**AGENDA**  
**CITY OF CEDAR FALLS, IOWA**  
**PLANNING AND ZONING COMMISSION MEETING**  
**WEDNESDAY, JUNE 23, 2021**  
**5:30 PM AT CITY HALL AND VIA VIDEO CONFERENCE**

**TO:** Planning & Zoning Commission  
**FROM:** Michelle Pezley, Planner III  
 Matthew Tolan, EI, Civil Engineer II  
**DATE:** June 16, 2021  
**SUBJECT:** Pinnacle Prairie South Commercial Phase V preliminary and final plat.

TO: Planning & Zoning Commission
FROM: Michelle Pezley, Planner III
DATE: June 17, 2021
SUBJECT: UnityPoint Clinic Site Plan: Case # SP21-006

**TO:** Planning & Zoning Commission  
**FROM:** Michelle Pezley, Planner III  
**DATE:** June 21, 2021  
**SUBJECT:** Hwy-1 Commercial Site Plan - 703 Brandilynn Blvd(Case # SP21-007)

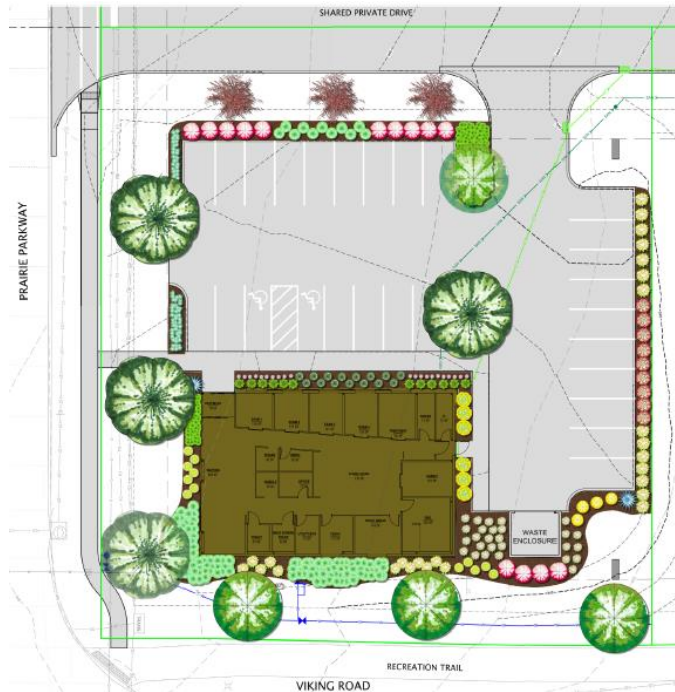
- 5) Landscaping: The HWY-1 District requires landscaping at the rate of 0.02 points per sq. ft. of total development site area which comes to 620 points required. Their plan achieves 835 points. An additional 450 points are required for street tree planting and their plan achieves 520.

Trees are required in the vehicular use area at the rate of one overstory tree per 15 parking spaces. This equates to a requirement of 2 overstory trees. That is the amount proposed within the parking area to meet this requirement.

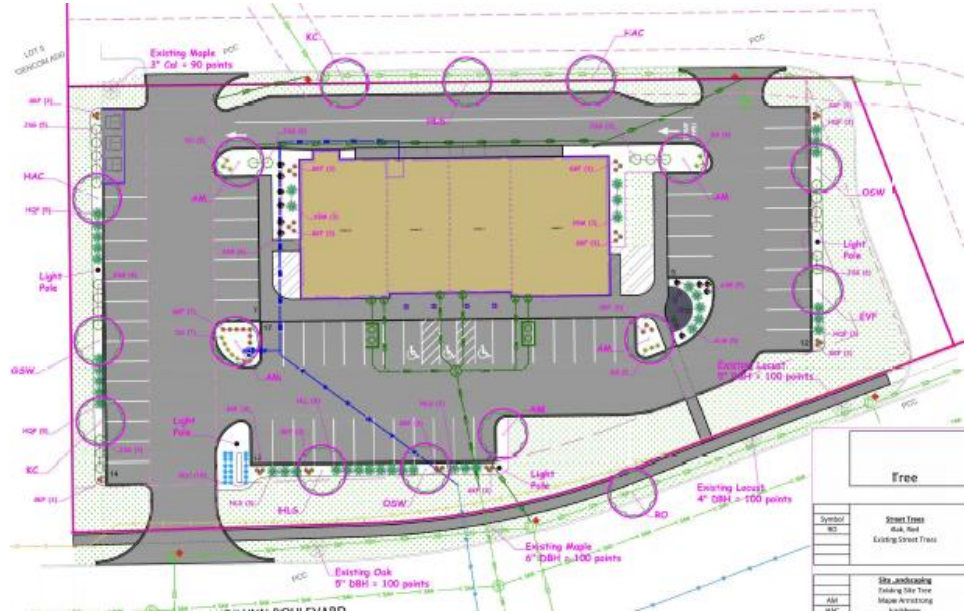
The HWY-1 District requires landscaping at the rate of 0.02 points per sq. ft. of total development site area which comes to 1,379 points required. Their plan achieves 1,895 points. An additional 306 points are required for street tree planting and their plan achieves 480. Four of the street trees are already planted.

In addition to the internal parking lot trees, there are trees required within the peripheral of the parking lot and along the street frontages. The applicant proposes landscaping islands with at least five feet wide with shrubs, grasses, and additional trees being located around parking areas. The landscaping screening is required for the entire parking lot which includes the internal circulation to be screened. **Staff proposes the condition that the applicant provide a revised landscaping plan to provide parking lot screening along the entire length of the property frontage along Brandilynn Boulevard according to City parking lot screening standards;**

- 1) Any comments or direction specified by the Planning & Zoning Commission.
- 2) Revision to the landscaping plan to provide parking lot screening along the entire length of the property frontage along Brandilynn Boulevard according to City parking lot screening standards;
- 3) Conformance with all staff recommendations and technical requirements.

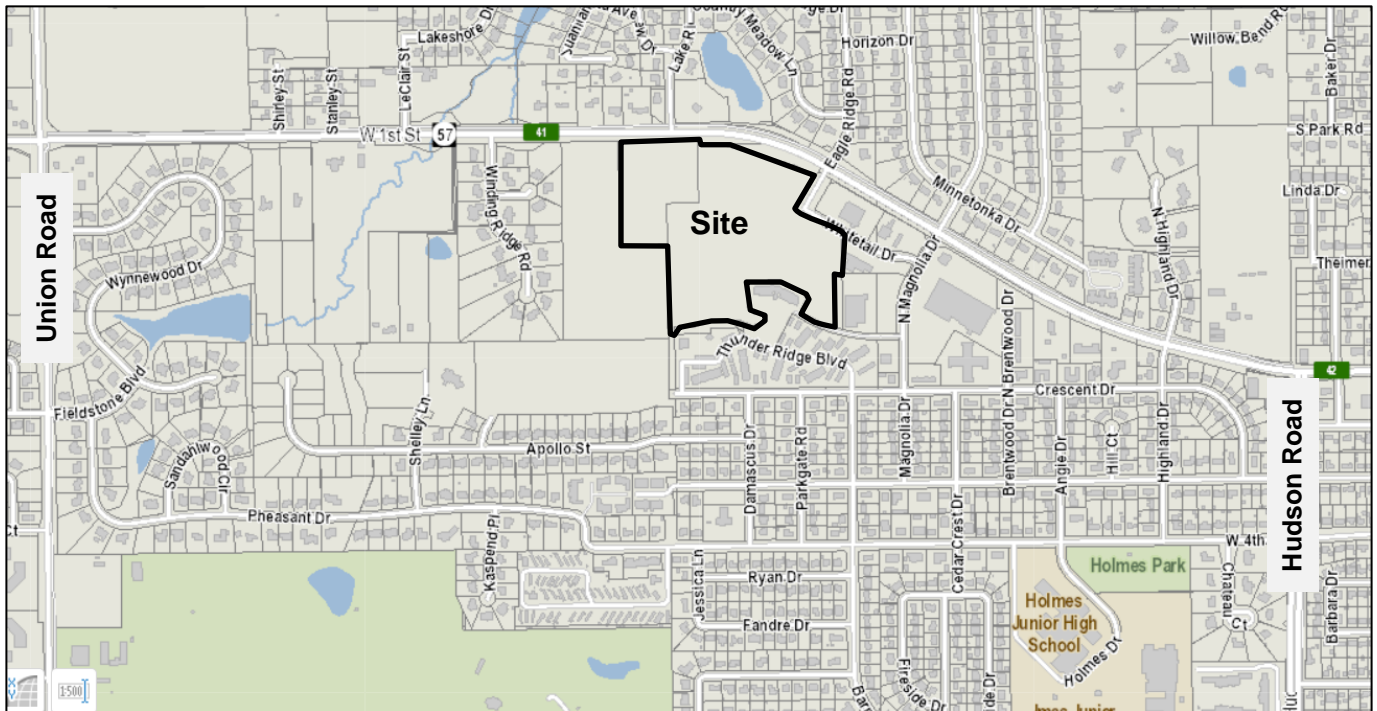
The extension of Lake Ridge Drive is a key connection in this area (see image below). The proposed development will bring new retail, entertainment and healthcare options to the area. Consideration should be given to how the adjoining neighborhoods have access to the site. Currently the options for the residents of the neighborhoods to the south to access the proposed development are limited. Magnolia Drive is the only north-south connection to W 1<sup>st</sup> Street between Hudson and Union Roads. The uses proposed along the 1<sup>st</sup> Street portion of the development will likely generate interest from areas south of the development. The development of Thunder Ridge and Lake Ridge Drive is one of few opportunities to provide a north-south connection.

In addition, the RP zoned property is dependent on access from the extension of Lake Ridge Drive. The applicant has propose two options for connections; one is an easement from the intersection of Whitetail Drive with Lake Ridge Drive and the other is an easement across the south side of the proposed full service restaurant lot (see the red outlines on the buffer exhibit page 7). Staff recommends the applicant extend Whitetail Drive beyond the intersection with Lake View Drive to the RP property.
